UNITED STATES PATENT AND TRADEMARK OFFICE

APPLICATION NO.	FILING DATE	FIRST NAMED INVENTOR	ATTORNEY DOCKET NO.	CONFIRMATION NO.
10/053,449	01/17/2002	Jim Bottos	108430.023	3550

Office Action Summary

- 1) ☒ Responsive to communication(s) filed on 18 June 0204.
- 2a) ☒ This action is **FINAL**. 2b) ☐ This action is non-final.
- 3) ☐ Since this application is in condition for allowance except for formal matters, prosecution as to the merits is closed in accordance with the practice under *Ex parte Quayle*, 1935 C.D. 11, 453 O.G. 213.

FIG. 1

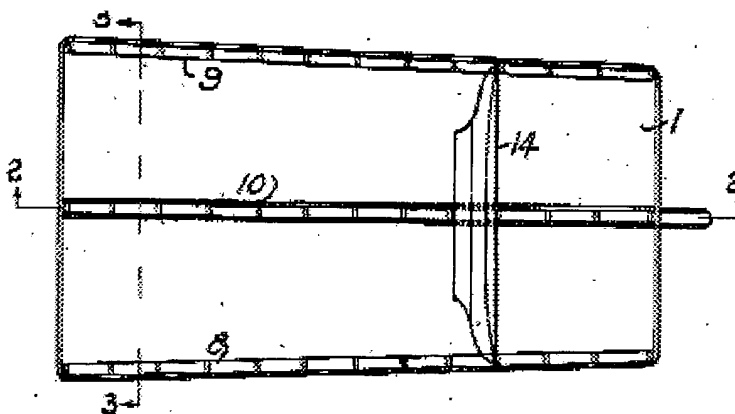
Re claim 14, Feingold discloses an article carrier comprising a wire frame having three load supporting members (8, 9, 10) having article engaging means (unnumbered, see labeled fig. below) and a core, that differs from the claims only in the recitation of the core having an outer coating and carrying wafers.

engaging means

supporting means

The patents to Sharaf and Field are each cited disclosing in a carrier for supporting an article; where the carrier is constructed of a wire frame with the frame having a core and

outer coating (see Sharaf, col. 1 lines 61-65 and Field col. 4, lines 39-41). It therefore would have been obvious to one having ordinary skill in the art to modify the carrier of Feingold, to have an outer coating as taught by either Sharaf or Field, for the purpose of preventing the rusting of the frame. As for the intended use/preamble of carrying a wafer, please note the same has not been afforded the effect of a limitation since the body of the claim is a self contained description of the structure and does not depend on the preamble for completeness (see MPEP 2111.02 **PREAMBLE STATEMENTS RECITING PURPOSE OR INTENDED USE**).
